ADDENDUM 3
RFP730-17141 Farish Hall Restroom Renovation
QUESTIONS AND ANSWER

ADDENDUM 5 - ADDITIONAL QUESTIONS & ANSWERS

RFP 730-17141 Issued 10/9/2017

Farish Hall Restroom Renovations to 3rd & 4th Floors

RFP783-17141
Farish Hall - Floors 3

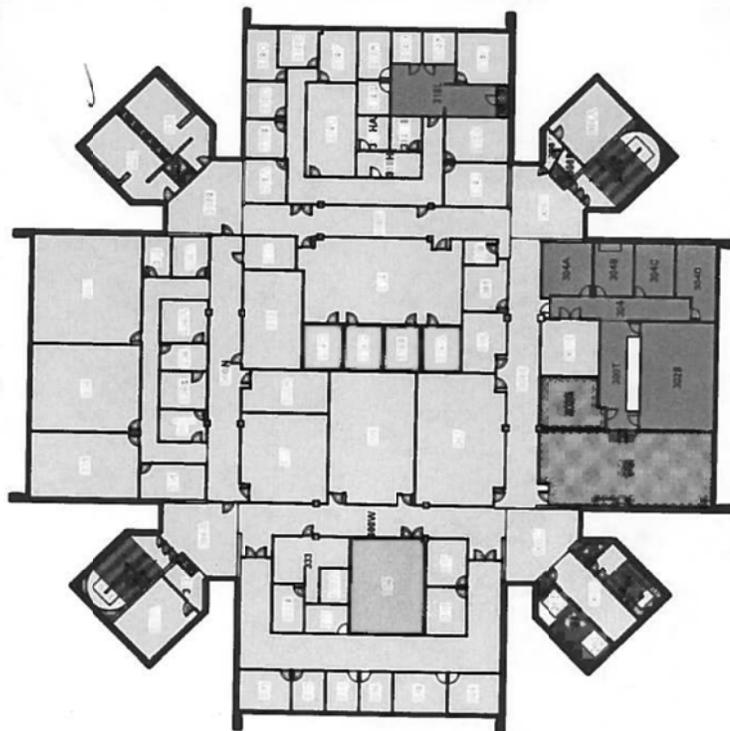
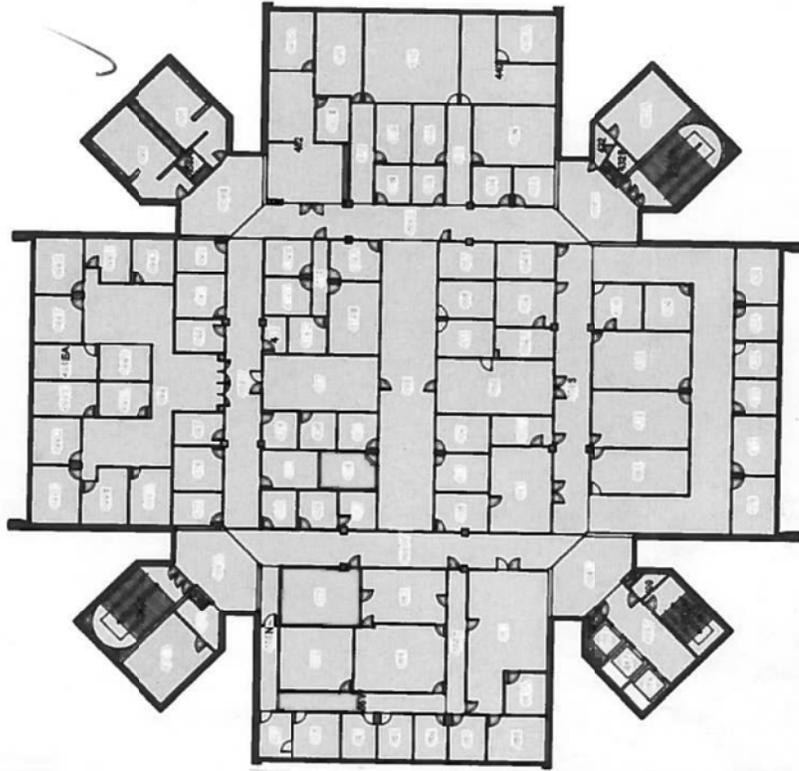
10. Please issue an overall building floor plan at levels three and four for logistical reasons to the work area.

RESPONSE: See attached floor plans of 3rd & 4th floors.
